Appendix 8. Bord na Mona Surface Water Monitoring Plan 2013.

Response to RFI (RI000285) In Relation to Surface Water Discharge Monitoring Programme

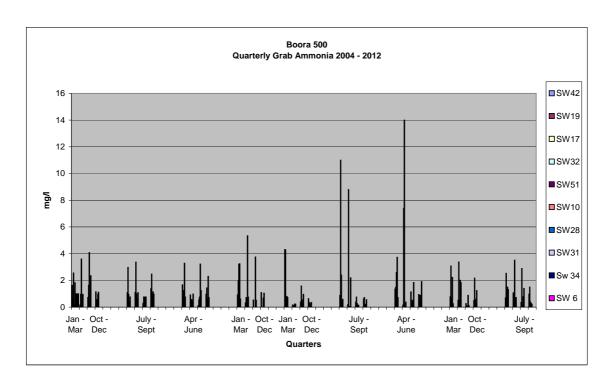
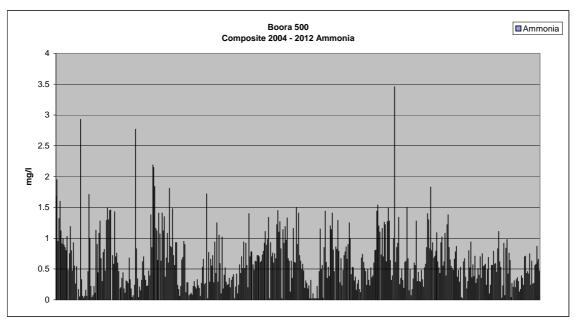
• Under licence condition 6.5, submit the trigger levels for Ammonia and the appropriate corrective action procedures.

6.14 The licensee shall, by 1" February 2013, establish a suitable trigger level for total ammonia in surface water discharges. The licensee shall have in place a response programme to address the attainment or exceedence of the trigger level value. This response programme shall include the necessary actions to ensure there will be no emissions to surface water of environmental significance.

In establishing trigger levels for ammonia (NH4-N) the results of quarterly grab samples from 10 sites were scrutinized from 2004 – 2012 for the 90 percentile value, ie the ammonia level that 90% of the results were below. Apart from some anomalies the max value recorded was 5.34 mg/l with a mean of 1.09 mg/l with 90% of results being less than 3.09 mg/l. Similarly Composite Sampler ammonia results from 2 sites

were scrutinized from 2004 – 2012, using the same methodology with results showing a max of 3.46 mg/l and a mean 0.64 mg/l with 90% being less than 1.26 mg/l. In selecting an ammonia trigger level it was decided to pick the quarterly grab figure of 3.09 mg/l as this is more representative of licence emission points which are required to be sampled at least once every 5 years under condition 6.2. The basis for the above findings is attached in graph format. Therefore the proposed ammonia trigger level for Boora IPPC Licence 500 is 3.09mg/l plus a freeboard of 20% giving a final trigger level of 3.70 mg/l.

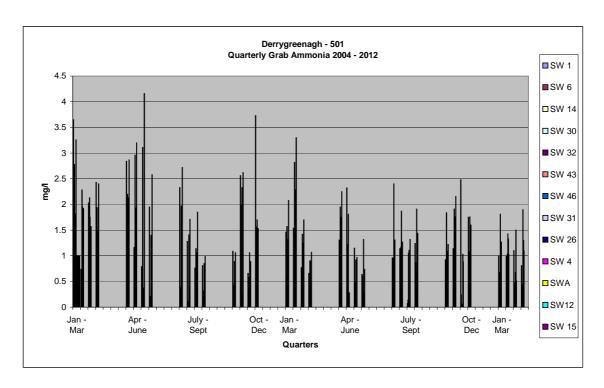
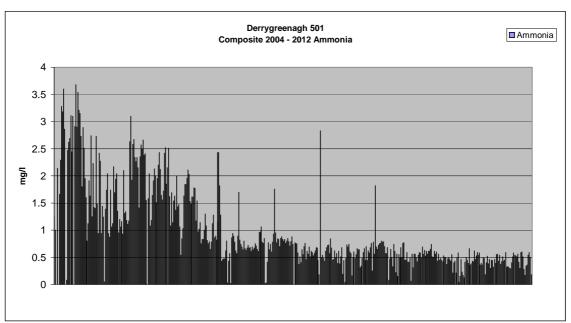
• Under licence condition 6.5, submit the trigger levels for Ammonia and the appropriate corrective action procedures.

6.14 The licensee shall, by 1" February 2013, establish a suitable trigger level for total ammonia in surface water discharges. The licensee shall have in place a response programme to address the attainment or exceedence of the trigger level value. This response programme shall include the necessary actions to ensure there will be no emissions to surface water of environmental significance.

In establishing trigger levels for ammonia (NH4-N) the results of quarterly grab samples from 13 sites were scrutinized from 2004 - 2012 for the 90 percentile value, ie the ammonia level that 90% of the results were below. The max value recorded being 4.16 mg/l with a mean of 1.16 mg/l with 90% of results being less than 2.32 mg/l. Similarly Composite Sampler ammonia results from 4 sites were scrutinized

from 2004 - 2012, using the same methodology results show a max of 3.68 mg/l and a mean 0.97 mg/l with 90% being less than 2.16 mg/l.

In selecting an ammonia trigger level it was decided to pick the quarterly grab figure of 2.32 mg/l as this is more representative of licence emission points which are required to be sampled at least once every 5 years under condition 6.2. The basis for the above findings is attached in graph format. Therefore the proposed ammonia trigger level for Derrygreenagh IPPC Licence 501 is 2.32 mg/l plus a freeboard of 20% giving a final trigger level of 2.78 mg/l.

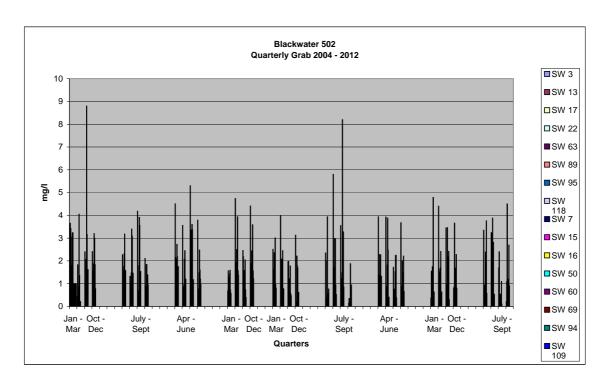
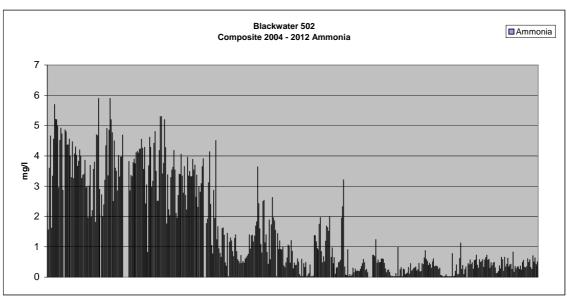
• Under licence condition 6.5, submit the trigger levels for Ammonia and the appropriate corrective action procedures.

6.14 The licensee shall, by 1" February 2013, establish a suitable trigger level for total ammonia in surface water discharges. The licensee shall have in place a response programme to address the attainment or exceedence of the trigger level value. This response programme shall include the necessary actions to ensure there will be no emissions to surface water of environmental significance.

In establishing trigger levels for ammonia (NH4-N) the results of quarterly grab samples from 16 sites were scrutinized from 2004 – 2012 for the 90 percentile value, ie the ammonia level that 90% of the results were below. Apart from some anomalies the max value recorded was 5.8 mg/l with a mean of 1.67 mg/l with 90% of results being less than 3.55 mg/l. Similarly Composite Sampler ammonia results from 3 sites

were scrutinized from 2004 – 2012, using the same methodology with results showing a max of 5.9 mg/l and a mean of 1.59 mg/l with 90% being less than 4.12 mg/l. In selecting an ammonia trigger level it was decided to pick the quarterly grab figure of 3.55 mg/l as this is more representative of licence emission points which are required to be sampled at least once every 5 years under condition 6.2. The basis for the above findings is attached in graph format. Therefore the proposed ammonia trigger level for Blackwater IPPC Licence 502 is 3.55 mg/l plus a freeboard of 20% giving a final trigger level of 4.26 mg/l.

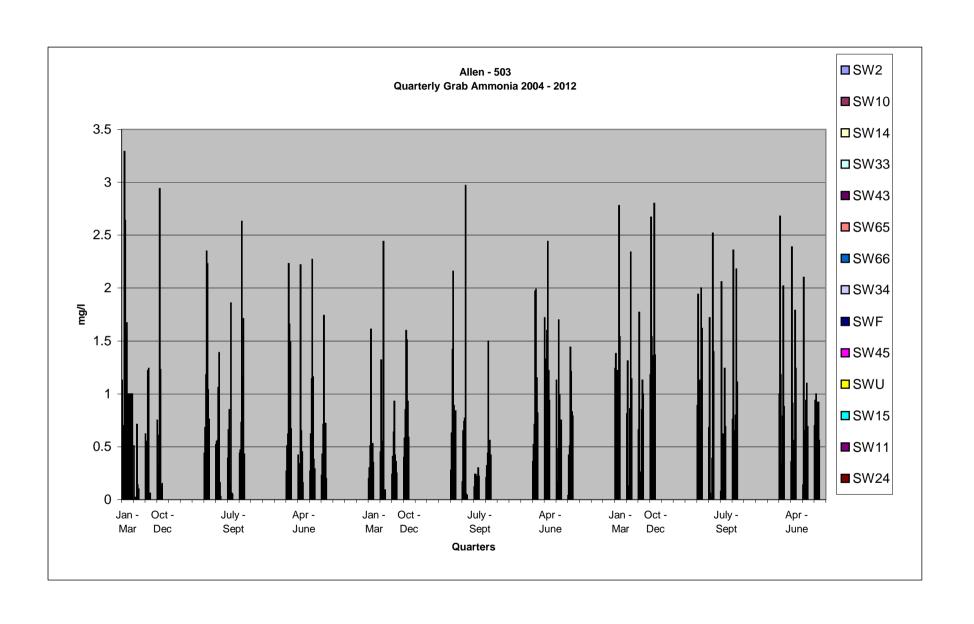
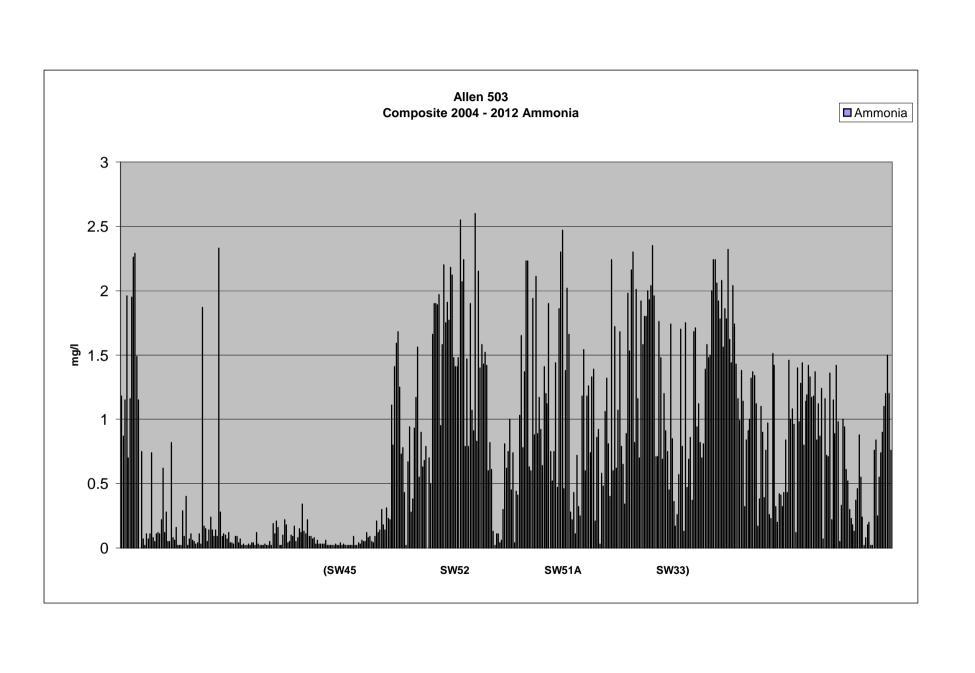
• Under licence condition 6.5, submit the trigger levels for Ammonia and the appropriate corrective action procedures.

6.14 The licensee shall, by 1" February 2013, establish a suitable trigger level for total ammonia in surface water discharges. The licensee shall have in place a response programme to address the attainment or exceedence of the trigger level value. This response programme shall include the necessary actions to ensure there will be no emissions to surface water of environmental significance.

In establishing trigger levels for ammonia (NH4-N) the results of quarterly grab samples from 14 sites were scrutinized from 2004-2012. The max value recorded being 3.29 mg/l with a mean of 0.898mg/l with 90% of results being less than 2.5 mg/l Similarly Composite Sampler ammonia results from 4 sites were scrutinized from 2004-2012, results show a max of 2.6mg/l and a mean 0.764 mg/l with only 0.42% being above 2.5 mg/l. It would appear that ammonia emissions from the

licence area are generally below 2.5mg/l however as there is no corrective actions available that could be implemented to reduce the incident of an exceedance in the trigger level, it is proposed to set a trigger level of 3 mg/l which is 20% above the experienced norm. This will allow a more realistic level of reporting in relation to ammonia trigger levels. The basis for the above findings is attached in graph format.

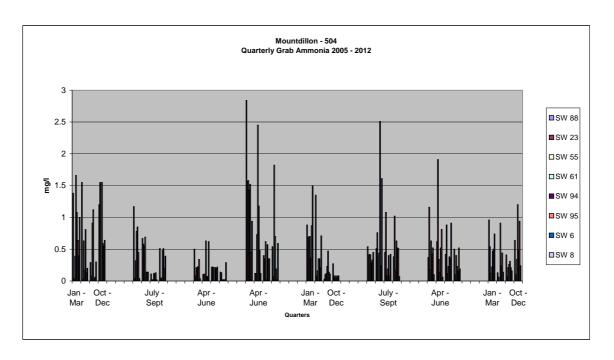
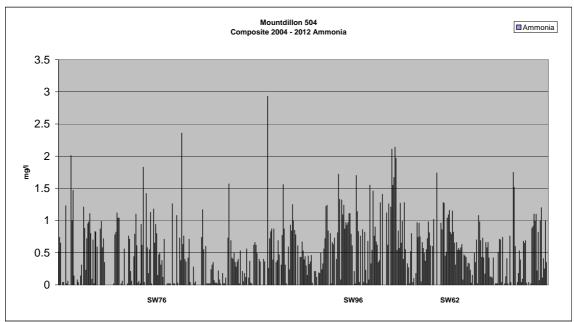
• Under licence condition 6.5, submit the trigger levels for Ammonia and the appropriate corrective action procedures.

6.14 The licensee shall, by 1" February 2013, establish a suitable trigger level for total ammonia in surface water discharges. The licensee shall have in place a response programme to address the attainment or exceedence of the trigger level value. This response programme shall include the necessary actions to ensure there will be no emissions to surface water of environmental significance.

In establishing trigger levels for ammonia (NH4-N) the results of quarterly grab samples from 8 sites were scrutinized from 2005 – 2012 for the 90 percentile value, ie the ammonia level that 90% of the results were below. The max value recorded being 2.84 mg/l with a mean of 0.47 mg/l with 90% of results being less than 1.19 mg/l. Similarly Composite Sampler ammonia results from 3 sites were scrutinized from

2004 - 2012, using the same methodology with results showing a max of 2.93 mg/l and a mean 0.58 mg/l with 90% being less than 1.17 mg/l.

In selecting an ammonia trigger level it was decided to pick the quarterly grab figure of 1.19 mg/l as this is more representative of licence emission points which are required to be sampled at least once every 5 years under condition 6.2. The basis for the above findings is attached in graph format. Therefore the proposed ammonia trigger level for Mountdillon IPPC Licence 504 is 1.19 mg/l plus a freeboard of 20% giving a final trigger level of 1.42 mg/l.

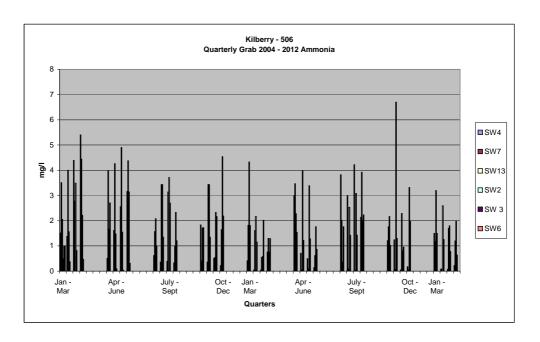
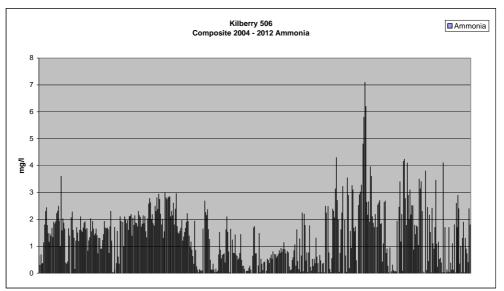
6.14 The licensee shall, by 1" February 2013, establish a suitable trigger level for total ammonia in surface water discharges. The licensee shall have in place a response programme to address the attainment or exceedence of the trigger level value. This response programme shall include the necessary actions to ensure there will be no emissions to surface water of environmental significance.

In selecting an ammonia trigger level it was decided to pick the quarterly grab figure of 3.78 mg/l as this is more representative of licence emission points which are required to be sampled at least once every 5 years under condition 6.2. The basis for the above findings is attached in graph format. Therefore the proposed ammonia trigger level for Kilberry IPPC Licence 506 is 3.78 mg/l plus a freeboard of 20% giving a final trigger level of 4.53 mg/l.
